Access Compliance Report

Public Rights-of-Way

(Curb Ramps)

Intersection ID: 12928	Main Street: PENMAN_ST	Cross Street: QUINCEY_ST	Location:	E
ADA ID: 0E3F9697C052	Ramp Type: PerpDiag	Initial Pass/Fail: Fail	Overall Compliance: No	Severity Score: 12.5

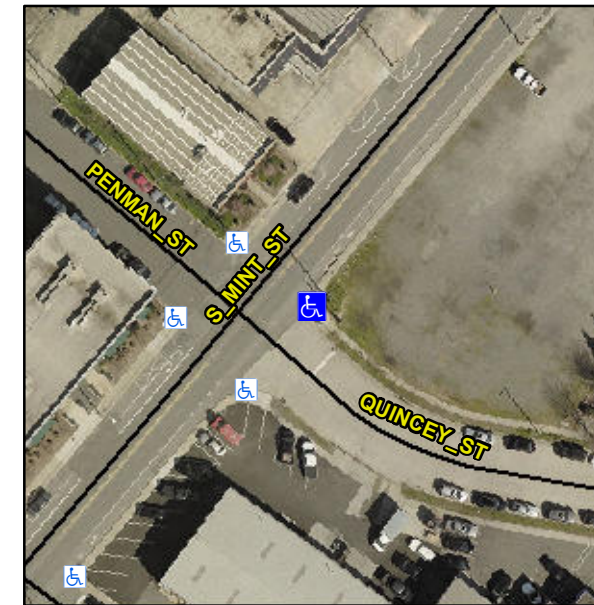
PROW/ADA:

Not Found, R304.2.2

Compliance	Description	Data	Compliance	Description	Data
N/A	Ramp Length (in)	60.0	No	Ramp Slope (%)	10.2
Yes	Ramp Width (in)	48.0	Yes	Ramp XSlope (%)	1.7
N/A	Flare Type LT	N/A	N/A	Flare Type RT	N/A
N/A	Flare Slope LT (%)	N/A	N/A	Flare Slope RT (%)	N/A
N/A	Flare Traversable LT?	N/A	N/A	Flare Traversable RT?	N/A
N/A	Landing Length (in)	N/A	N/A	DWS Provided?	N/A
N/A	Landing Width (in)	N/A	N/A	DWS Contrast?	N/A
N/A	Landing Slope (%)	N/A	N/A	DWS Length (in)	N/A
N/A	Landing X Slope (%)	N/A	N/A	DWS Full Width?	N/A
N/A	Landing Curb? (Y/N)	N/A	N/A	DWS Offset (in)	N/A
N/A	Shared Landing?	N/A			
N/A	Gutter Ponding?	N/A	N/A	Gutter Slope (%)	N/A
N/A	Gutter Lip Ht (in)	N/A	N/A	Gutter X Slope (%)	N/A
N/A	Painted X Walk1?	No	N/A	Painted X Walk2?	No
	X Walk 1 Direction	To NW		X Walk 2 Direction	To SW
N/A	X Walk 1 Width (in)	N/A	N/A	X Walk 2 Width (in)	N/A
	X Walk 1 Slope (%)	4.8		X Walk 2 Slope (%)	5.5
	X Walk 1 X Slope (%)	0.6		X Walk 2 X Slope (%)	0.8

Possible Solutions:

Remove & Replace Curb Ramp With Two New Directional Ramps or Equivalent.
